Re: Tamarack Ridge (LP-07-00018), Starlight Heights (LP-07-00016) and Meadow Springs Plats
(LP-07-00015)

TO: Anna Nelson, CDS
FROM: Christina Wollman, Planner II
DATE: October 27, 2009
SUBJECT: SEPA Mitigation: Meadow Springs P-07-15, Starlite Heights P-07-16, Tamarack Ridge P-07-18

SUBJECT: Meadow Springs, Starlite Heights, and Tamarack Ridge – Traffic Impact Analysis

Right-Turn Lane Guidelines (6)
Figure 910-11

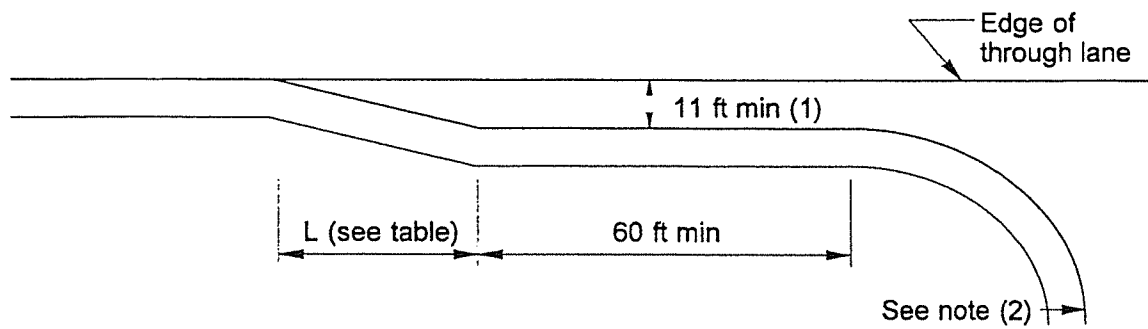
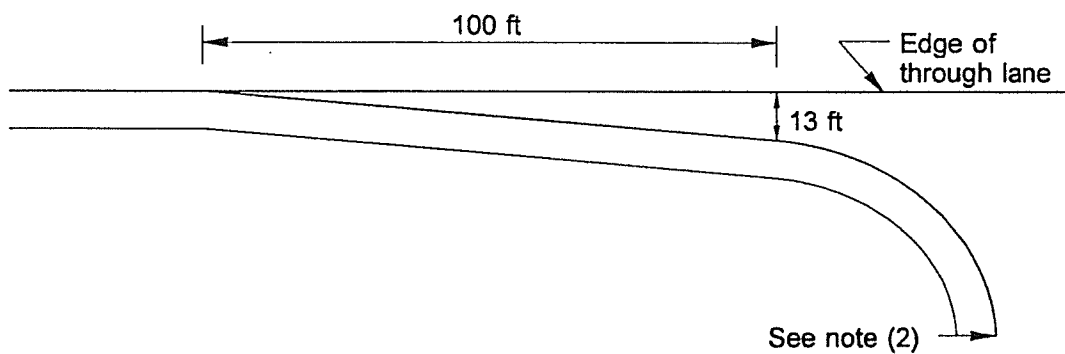
1. Right Turn Pocket/Taper: Traffic volumes generated by these residential developments warrant the addition of a right turn pocket or right turn taper from Westside Road eastbound into the development site access. The applicant shall design, receive approval from Public Works for the design, and construct this improvement. The configuration requirements are shown in Figure 910-12 of the WSDOT Design Manual (see attachment).
